Access Compliance Report

Public Rights-of-Way

| Intersection ID: 3307 | Main Street: SUTTONVIEW_DR | Cross Street: LOOKOUT_POINT_DR | Location: E |
| ADA ID: ACB4F37C32C4 | Ramp Type: PerpDiag | Initial Pass/Fail: Fail | Overall Compliance: No |

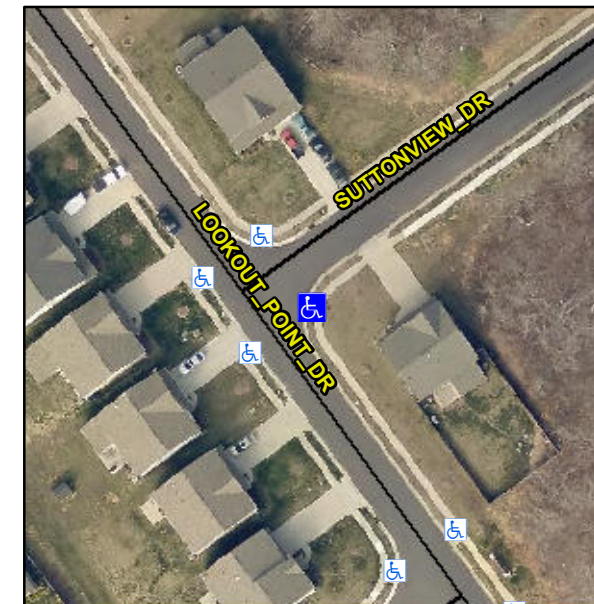
Not Found, R304.5.1, R304.5.3

| Compliance | Description | Data | Compliance | Description | Data |
|------------|-----------------------|-------|------------|-----------------------------|-------|
| N/A | Ramp Length (in) | 49.0 | Yes | Ramp Slope (%) | 5.8 |
| No | Ramp Width (in) | 47.5 | No | Ramp XSlope (%) | 4.1 |

Remove & Replace Curb Ramp With Two New Directional Ramps or Equivalent.
